West Virginia Northern Community College: Parking Lots & Green Space**RFB: 21060****Mandatory Prebid Meeting Minutes/ADDENDUM #1****Date:** August 17, 2020**Time:** 1:30 PM**Meeting Location:** WVNCC Auditorium**Attendees:**

**PHOTO A1: REMOVE STEEL
BOLLARD AND FOUNDATION**

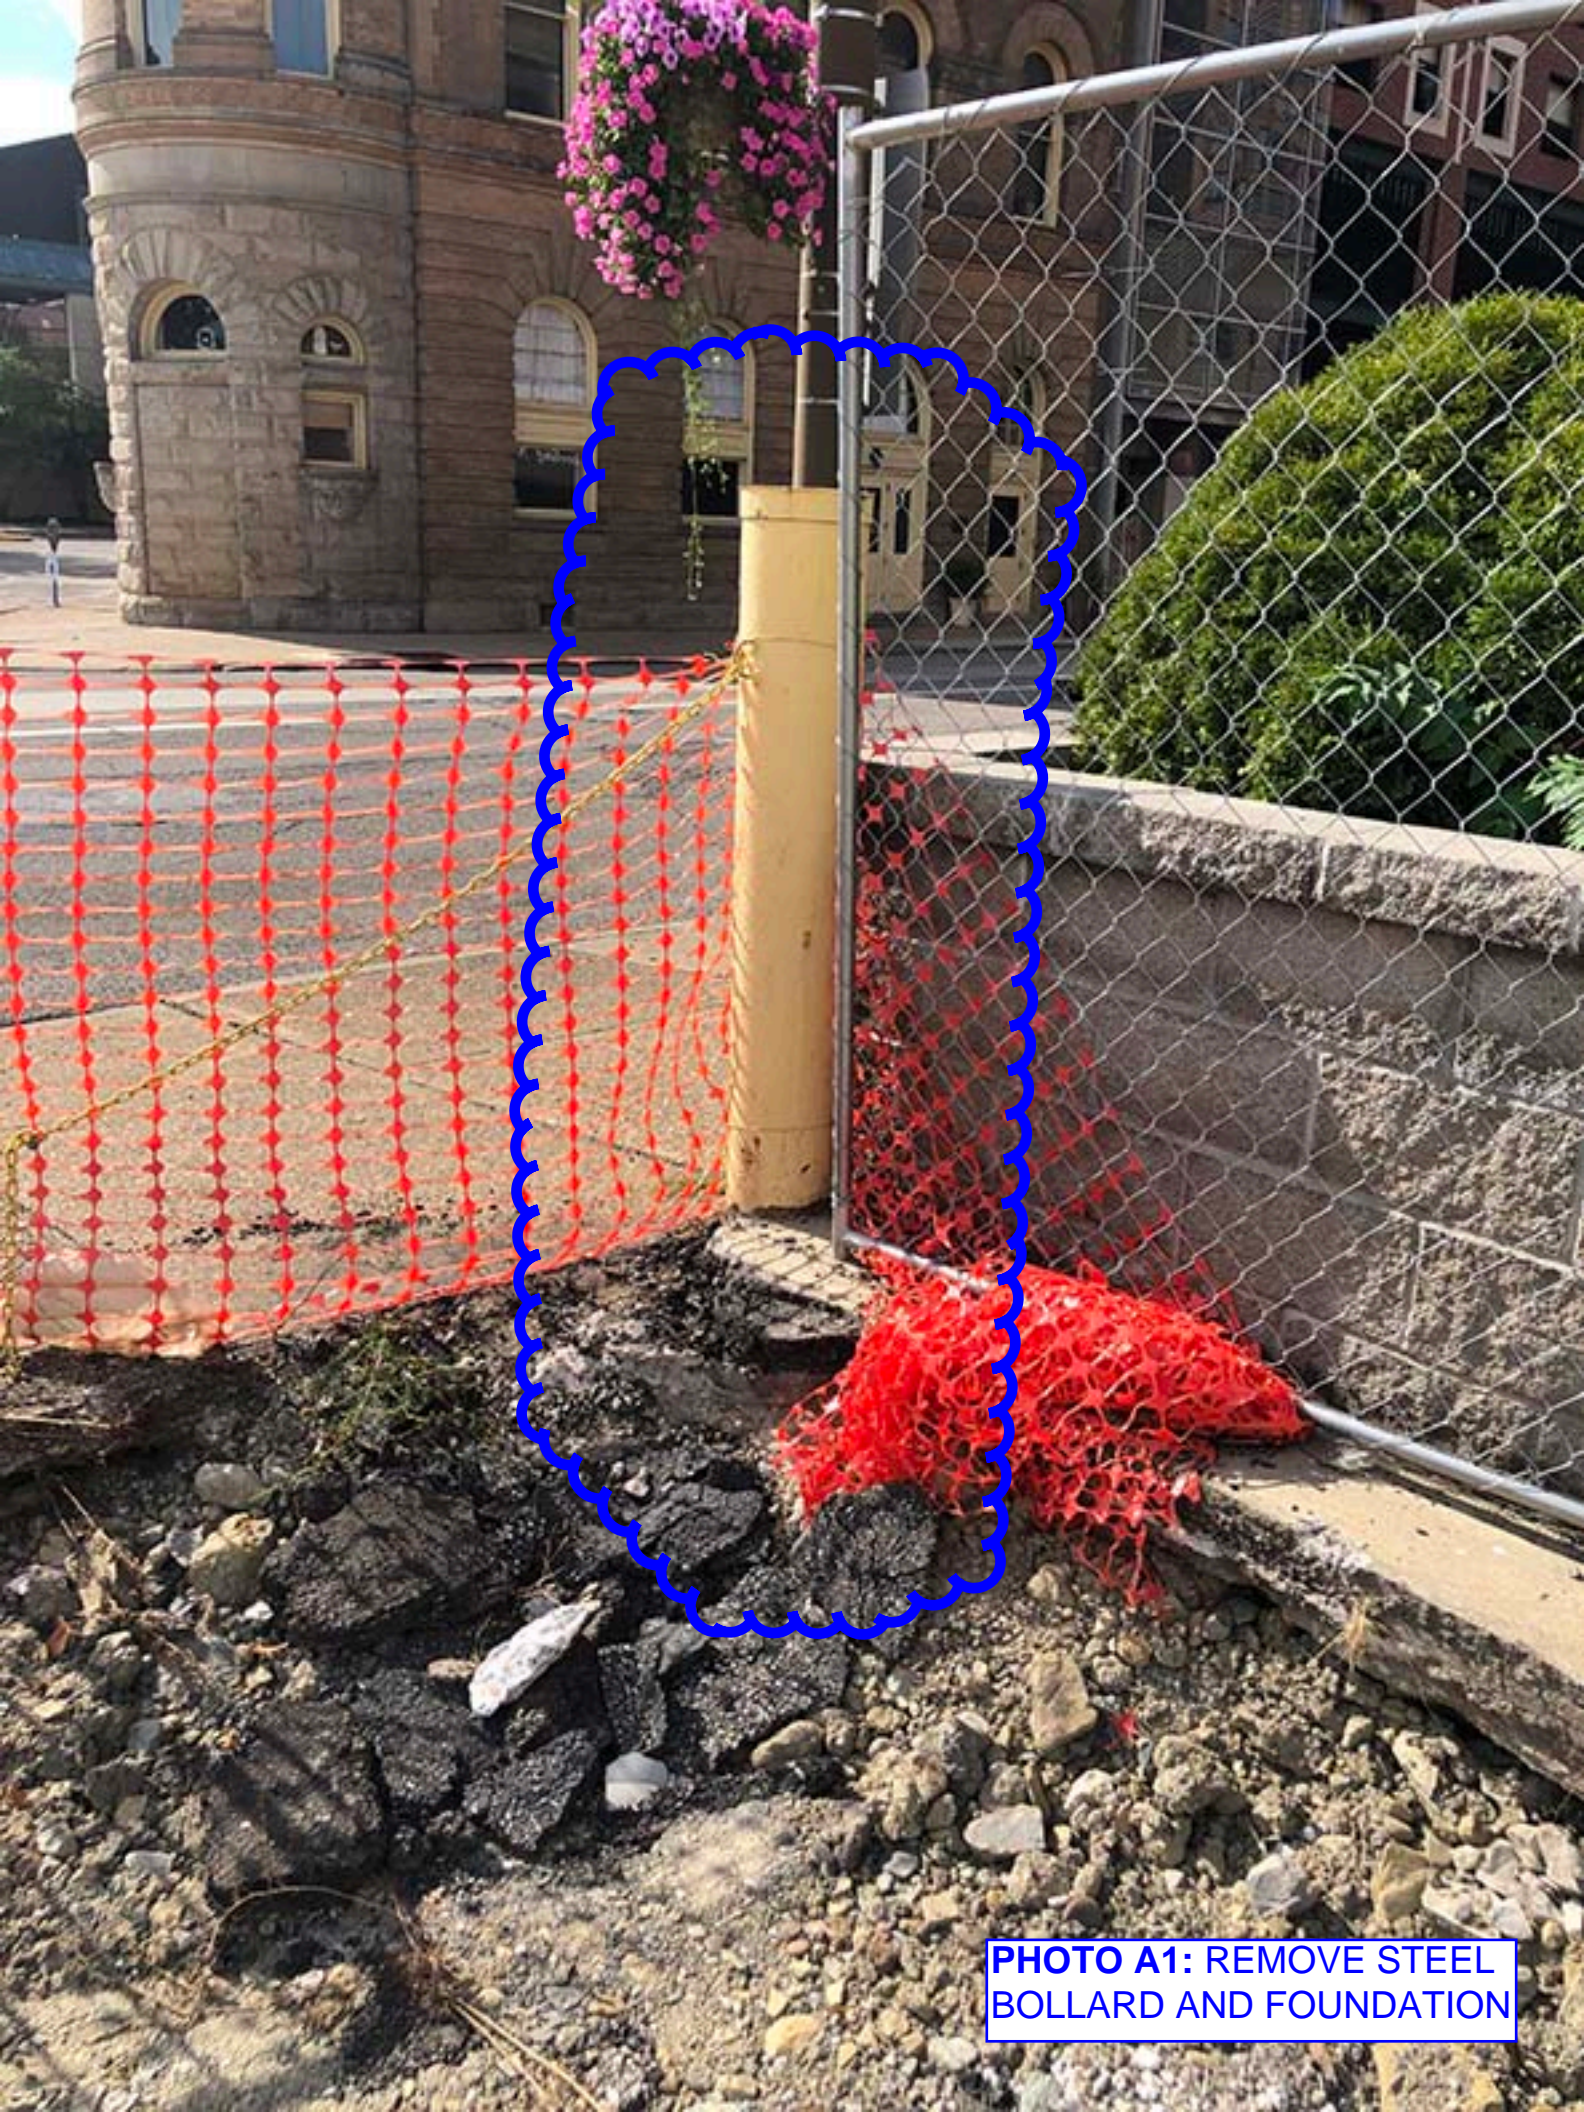
- (1) **Photos A1 & A2- Complete Bollards Removal (refer to the attached photos):** Two (2) steel bollards in NW and NE corners of the lot will need to be torched/cut 12" below finish grade and filled with flowable fill material.
- (2) **Photos B1 & B2- Partial Bollards Removal (refer to attached photos):** Completely remove remaining portion of two (2) steel bollards and foundations along Lane B to an elevation below proposed subgrade.
- (3) **Photo C- Concrete Paving Removal. (refer to attached photo):** Sawcut and remove a 15 ft long x 2.5 ft wide section of concrete base that sticks out into the site from the existing sidewalk along 16th Street adjacent to existing AEP vault.
- (4) **Photo D- Millstone Relocation (refer to attached photo):** Relocate millstone (3 ft dia. x 1 ft ht.) from the ATC Lot top the ECS Lot. Coord. relocation with Architect and Owner.

**PHOTO A2: REMOVE STEEL
BOLLARD AND FOUNDATION**

**PHOTO B1: REMOVE
PARTIAL STEEL BOLLARD
AND FOUNDATION**

**PHOTO B2: REMOVE
PARTIAL STEEL BOLLARD
AND FOUNDATION**

**PHOTO C: SAWCUT AND
REMOVE CONCRETE BASE
(APPROX. 15' LONG BY 2.5'
WIDE)**

**PHOTO D:RELOCATE
MILLSTONE FROM ATC LOT
TO ECS LOT. COORD.
RELOCATION WITH OWNER
AND ARCHITECT.**
